Planning Review Meeting

Wednesday 5 September 2012 at 7:00pm

4.2 10 CHESHUNT STREET, POINT LONSDALE

Planning Permit Application: 2012/051

Title: PROPOSED VEGETATION
REMOVAL PLAN

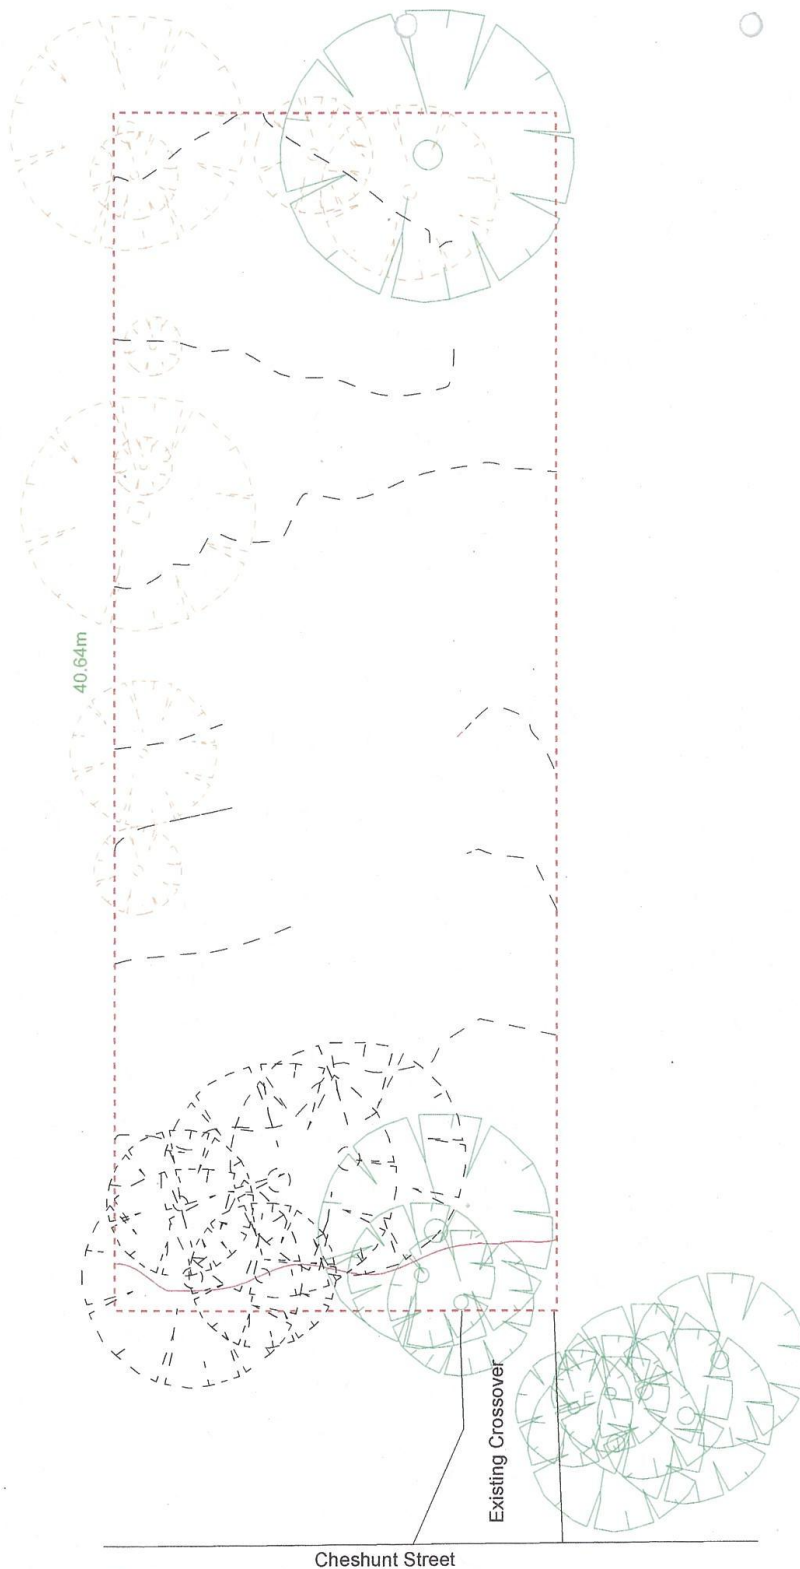
- Regardless of any replacement planting, these old established and irregularly planted trees have a natural look. They are a true feature of the lower end of Cheshunt Street. No ordinary symmetrical or conventional planting of young trees will replace or compensate for their iconic Point Lonsdale look.
- Further, there has been a progressive denuding of the road reserve as one moves east down Cheshunt Street towards the beach. The existing trees are old and established, of considerable character and size. The removal of trees adds to the deteriorating loss of amenity and character in the lower part of this 'old Lonsdale' Street.
- Thirdly, the removal of the Moonahs at the front is necessitated (at least in part) by the decrease in the setback distance of the proposed house.
- We object to the removal of the Moonahs from the back yard for the same reason.

- Overdevelopment for the site coverage
- Front site coverage
- Why at Pt Lonsdale have an underground carpark and such a large one?
- If the developer has to have an underground car park why can't the developer save the Moonah trees in the front garden by building a smaller underground car park?
- Where is the landscape plan?

- Removal of native vegetation. This is covered extensively in the written component of the submission and is supported by a full arborist report and a complete relandscaping plan. The VPO applicable to the site does not prohibit the removal of native vegetation and requires that where this is proposed that offset planting occur, an arborist report be provided and that a landscape proposal be included. All of these requirements have been met in the submission.

There is no requirement for native vegetation removal to seek a permit or approval from DSE on private land unless the area is covered by an Interim Conservation Order. No such order applies in Cheshunt Street and reference is therefore only made to the VPO in the planning scheme. The provided written and drawn information details each tree on site by species, condition and suitability for retention. There are no Moonahs to be removed from the rear garden;
